**WARRANTY
BULLETIN**

WB14-42A

DATE :	AUGUST 2014	SECTION :	06 - Electrical
EXPIRATION:	AUGUST 2016		
SUBJECT :	GATEWAY MODULE POWER SOURCE

Rev :C This bulletin supersedes previous versions

Figure 4

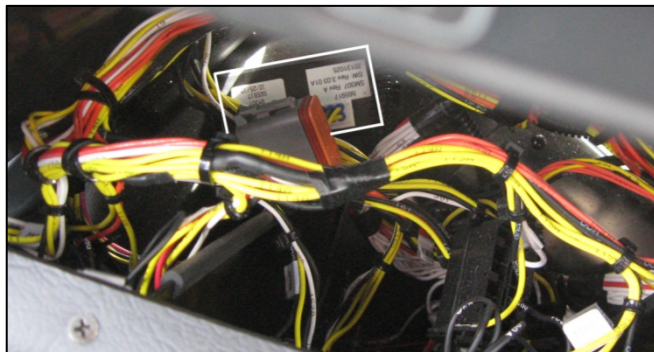
- A2. Locate gateway module. It is installed flat, behind the left portion of the dashboard.
- A3. Check module revision label. (Fig 4)
If it is **SM320 REV:A SW REV:1.00** and up, jump to **STEP B** below.

Figure 5

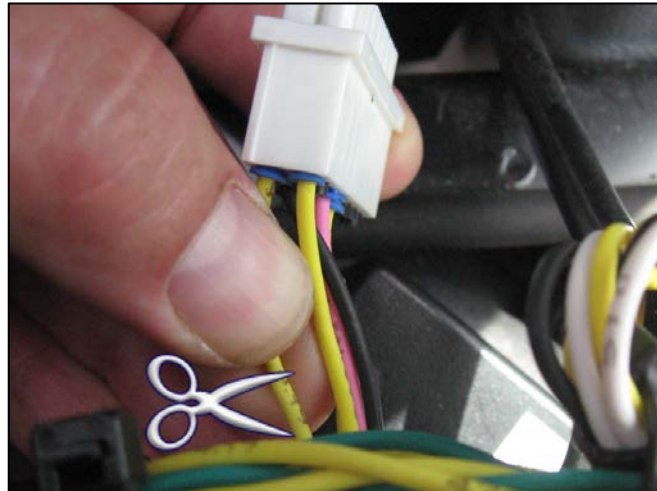
- B1. Unplug Connector to Gateway module A139.
- B2. Locate wire **439** at **pin 1** of Gateway Module A139. (Fig 5)
- B3. Cut about two inches away (50mm) from connector. (Fig 5)

Protect and seal bare wire end coming from dash with shrink tubing.

Figure 6

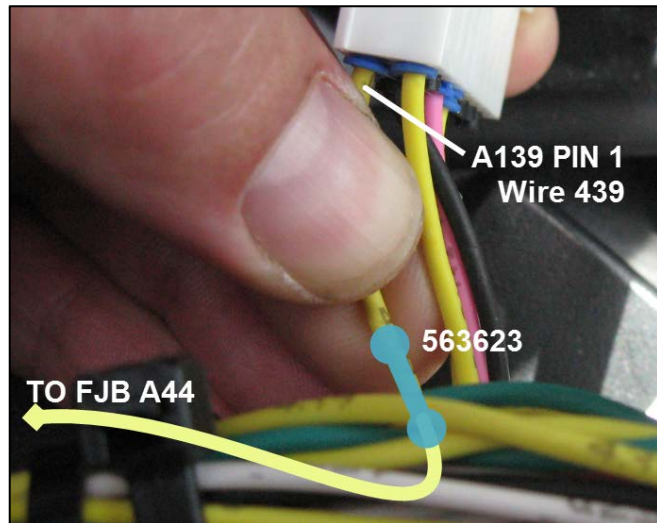
- B4. Run a new yellow 16ga **GXL** wire (560661 or equiv.) from A44 module in Front Junction Box to Gateway module.

Strip and connect to wire 439 coming out of gateway module connector pin 1 and new wire from front service compartment (FJB).

Use thermal shrink butt splice 563623. (Fig 6)

Figure 7

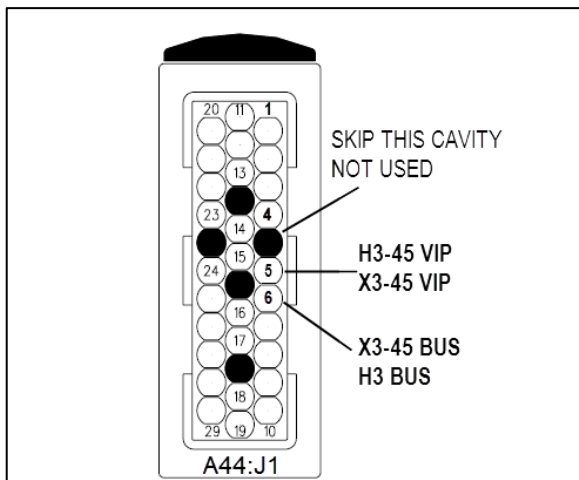
B5. Connect new wire to **A44:J1** using terminal 563692. (Fig 7)

Pin: 5 for H3-45 **VIP** and X3-45 **VIP**.

Pin: 6 for H3 **BUS** and X3-45 **BUS**
